February 18, 2000

Subject: USNRC Docket No. 72-1008; TAC No. L22019
HI-STAR 100 Storage CoC 1008
License Amendment Request 1008-1, Supplement 2

Enclosures: 1. Mark-ups of CoC 1008, Appendix B (4 pages)
2. Sketch of QUAD+ Criticality Model (1 page)

MCNP Model of QUAD+ Assembly with Dimensions

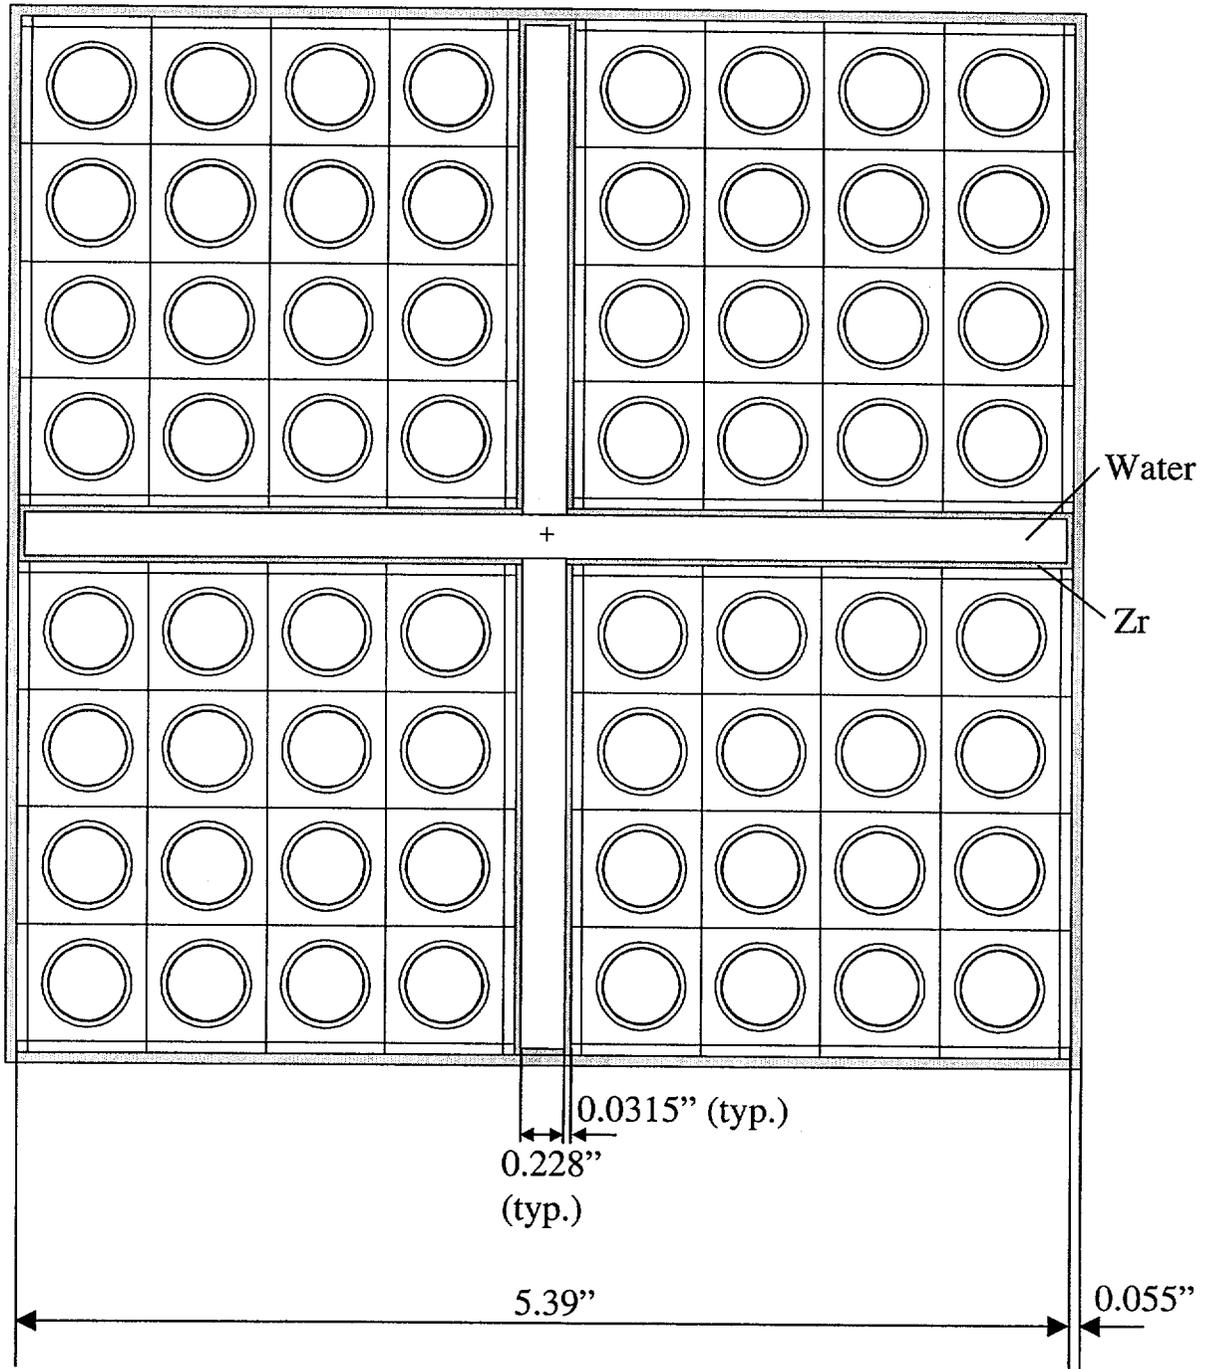
As committed during our telephone conversation yesterday, we enclose herewith replacement pages for proposed changes to HI-STAR Part 72 Certificate of Compliance (CoC) 1008 and a sketch of the criticality model of the QUAD+ assembly. The changes to the CoC involve clarifying the burnup table for assemblies containing burnable poison rod assemblies and thimble plug devices, and clarifying the requirements for Antimony-Beryllium neutron sources.
